TECHNICAL BULLETIN

PRIMAAX® / FIREMAAX® Support Beam Assembly

SUBJECT: Discontinued Support Beam Assemblies

LIT NO: SEU-0229

FIGURE 1

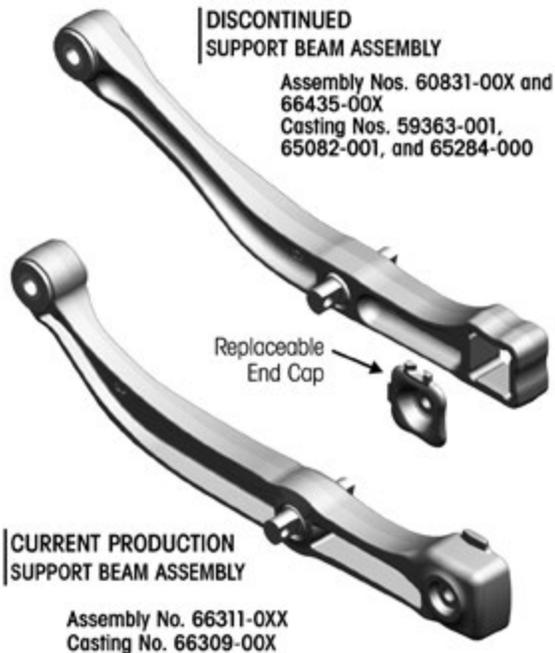
Effective May 1, 2010, support beam assembly part numbers 66435-00X or 60831-00X (Forging Part Nos. 59363-001, 65082-000, and 65284-000) for PRIMAAX® / FIREMAAX® suspension systems will be discontinued for field service purposes for North and Central America, see Figure 1.

Likewise Hendrickson will only offer U-beam assembly service kits (part number 60961-XXX, see Figure 2) for any necessary replacement of PRIMAAX / FIREMAAX support beam assemblies (part numbers 66435-00X or 60831-00X) in the field. Refer to Table 1 on Page 3 to determine the U-beam assembly service kit for each respective vehicle manufacturer.

FIGURE 2

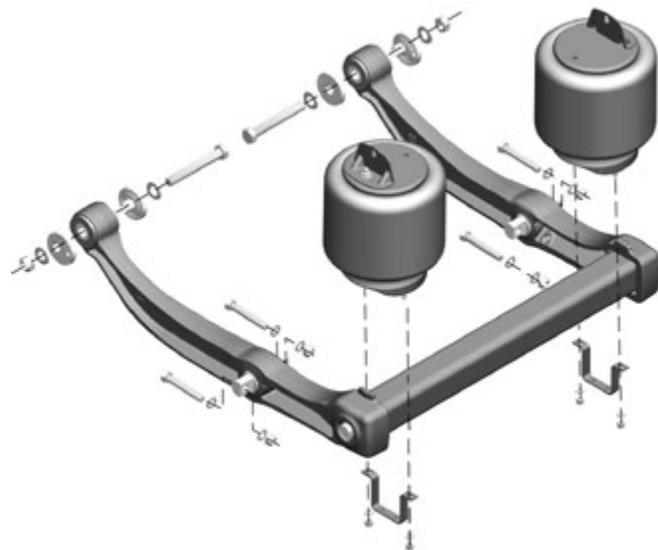
The U-beam assembly service kits (Part No. 60961-XXX, see Figure 2) are designed for the discontinued support beam assemblies and their related components on one axle and do not require additional drilling or modifications.

DO NOT USE A COMBINATION OF A DISCONTINUED (PART NOS. 60831-00X OR 66435-00X) WITH CURRENT PRODUCTION (PART NO. 66311-0XX) SUPPORT BEAM ASSEMBLIES ATTACHED TO THE SAME (AXLE) CROSS TUBE. USE OF DIFFERENT SUPPORT BEAM ASSEMBLIES AND/OR AIR SPRINGS ON THE SAME (AXLE) CROSS TUBE CAN RESULT IN VEHICLE LEAN AND/OR VEHICLE HANDLING PROBLEMS. IT IS ALLOWABLE TO HAVE DIFFERENT U-BEAM ASSEMBLY TYPES ON DIFFERENT AXLES.

Each service kit, see Figure 2, is intended for servicing the associated suspension parts on one axle, and includes two new support beam assemblies, one cross tube, two air spring assemblies, air spring hardware, QUIK-ALIGN® hardware and D-pin hardware.

FIGURE 3

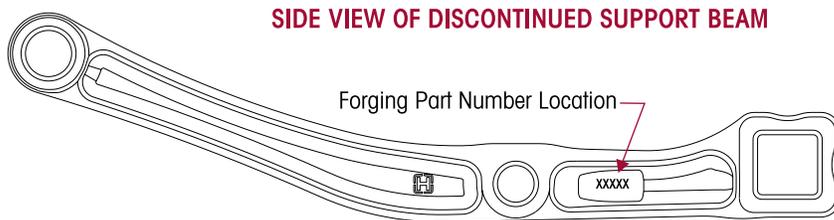
The support beam forging number, see Figure 3, can be used to help identify the support beam assembly part numbers and the U-beam assemblies that contain them. Support beam assembly part numbers are not shown on the beam.
